PUBLIC UTILITY DISTRICT NO. 1 of CHELAN COUNTY

Re: Rocky Reach Hydroelectric Project No. 2145
License Article 406 – Final Entiatqua Trail Construction Drawings
Request for Expedited Review and Approval of Entiatqua Trail Contract Plans and
Specifications

CHELAN PUD RESPONSE TO NMFS 7-27-12 COMMENTS

SHEET 5 OF 38
REVISION 0
DATE 2/19/2013
DWG. 0911-50CI-0014

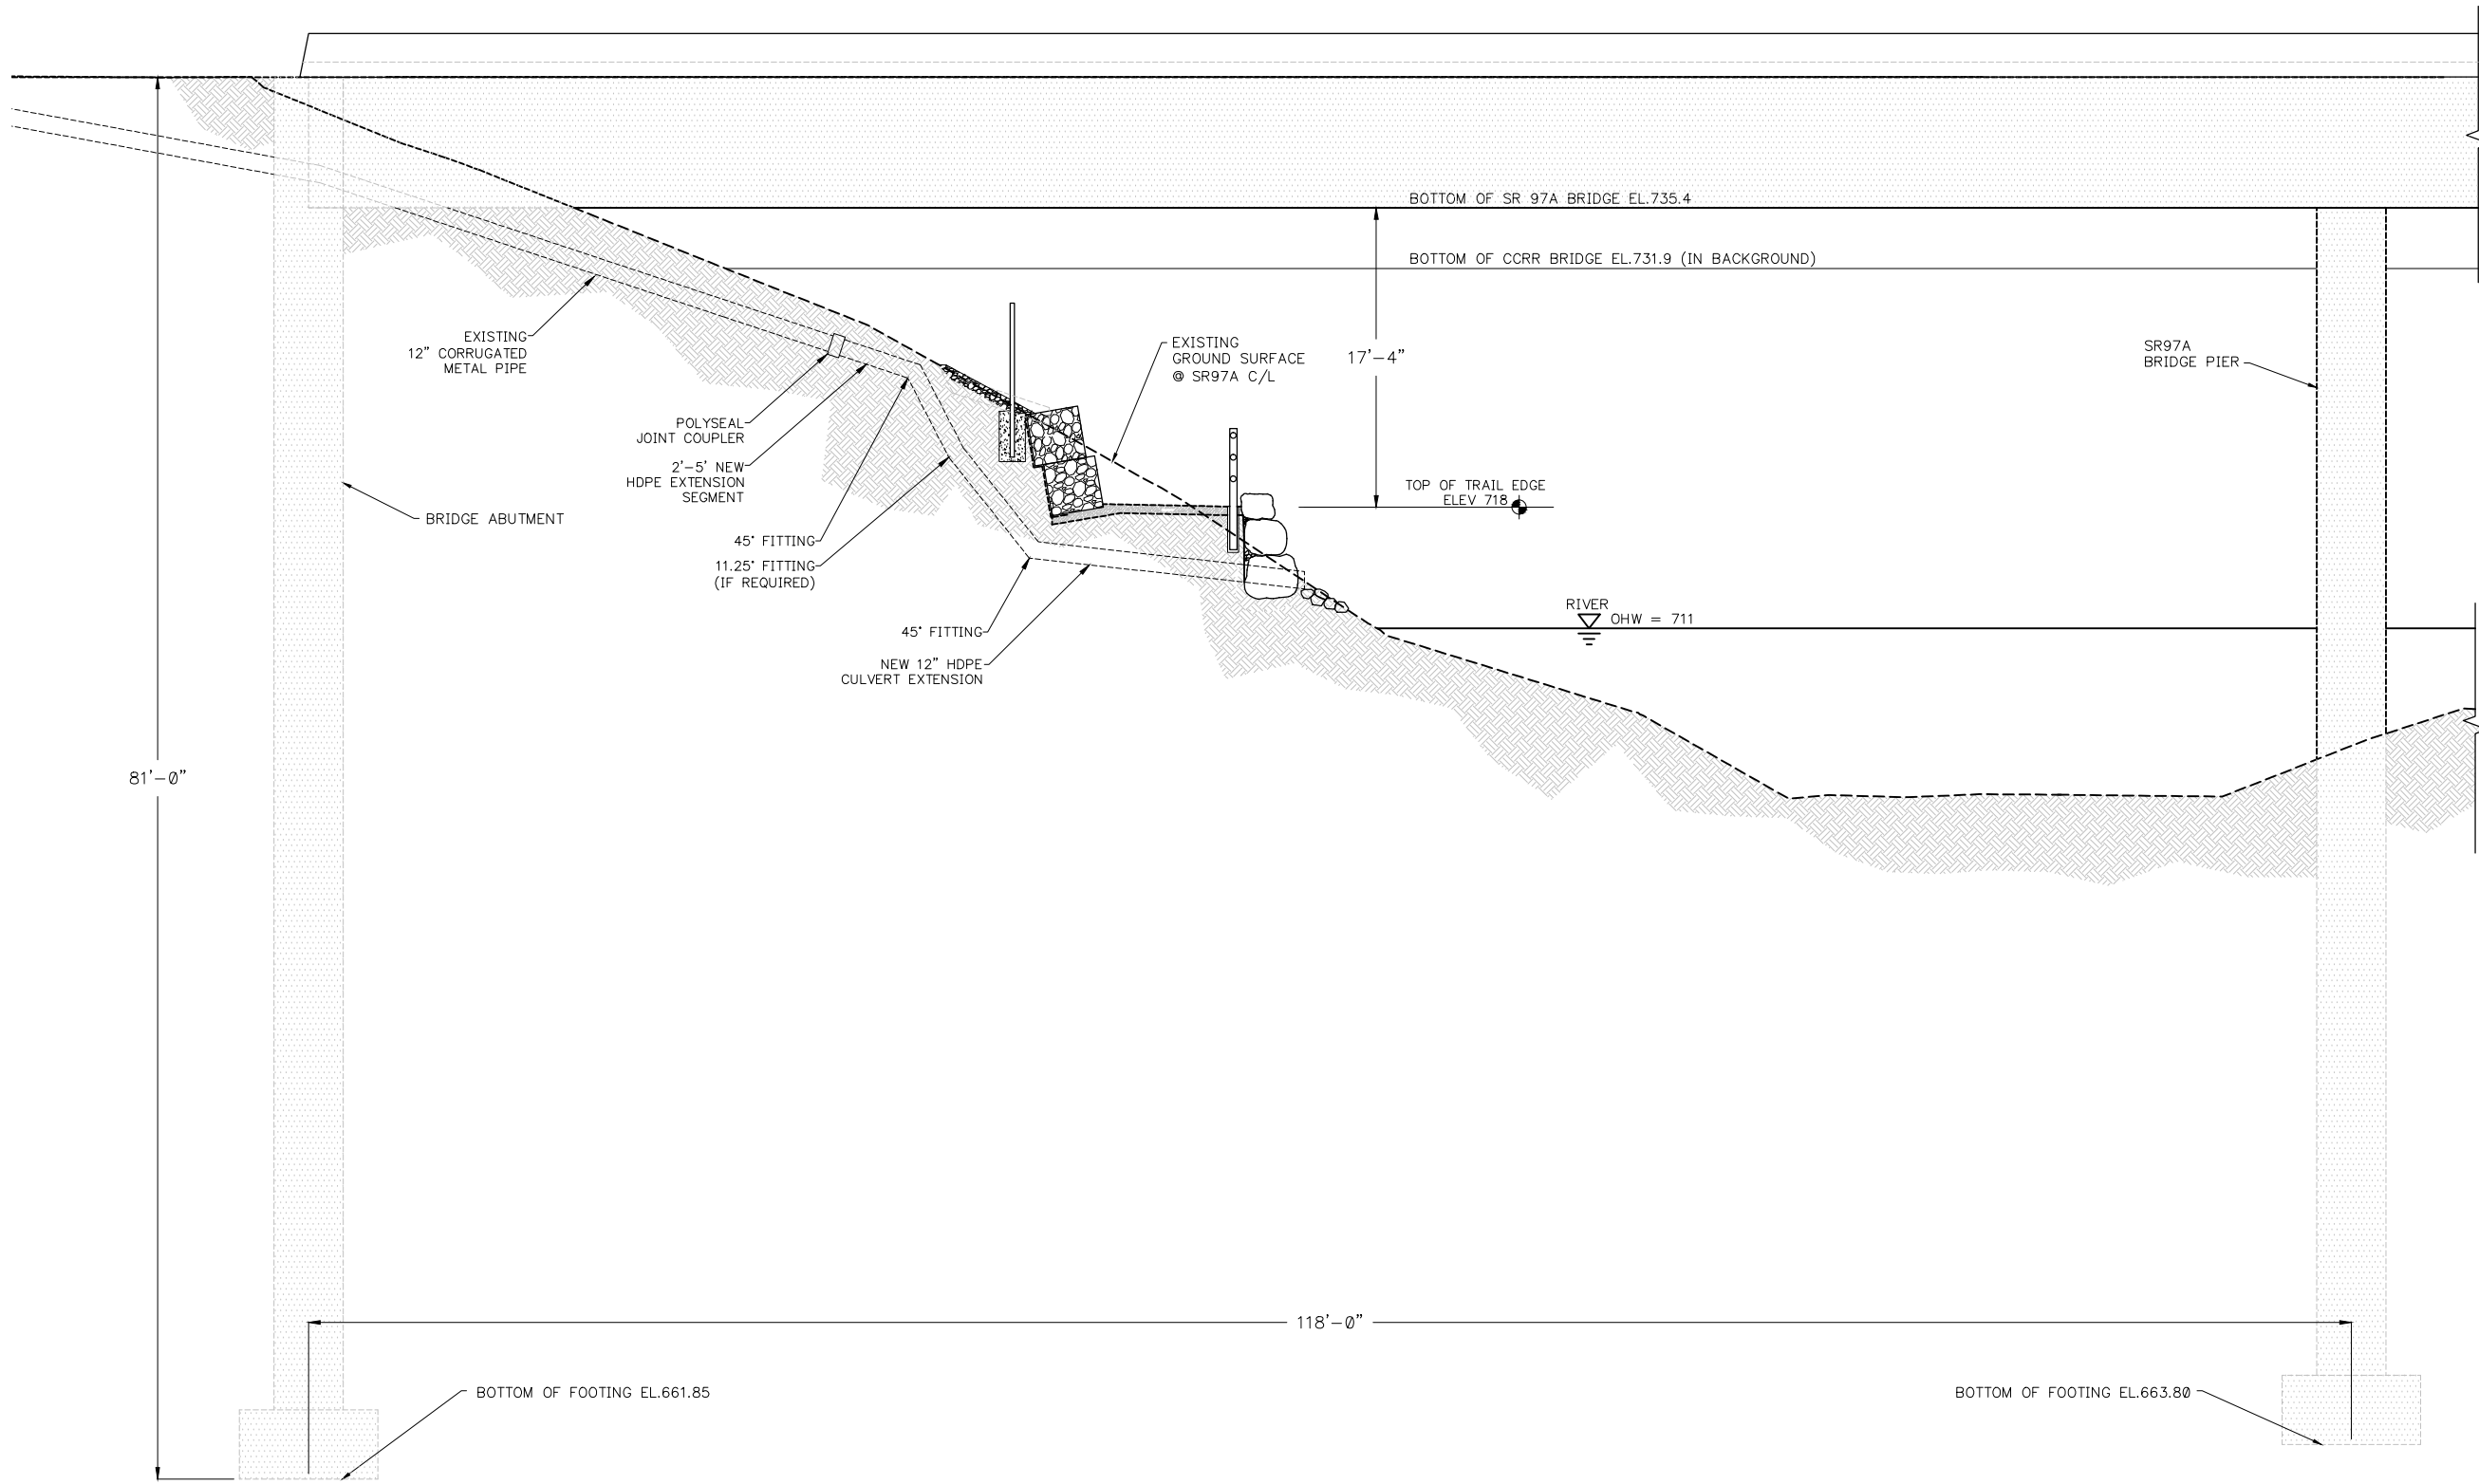
- On sheet 5 of the engineered drawings for the project we noticed Chelan PUD is proposing to remove existing nonnative trees (Elm). We recommend replacing them at a minimum ratio of 3:1 with native trees.

The project involves removing 2 nonnative elm trees. These trees will be replaced by planting 16 native trees (8:1 replacement ratio). See sheets 24 and 29.
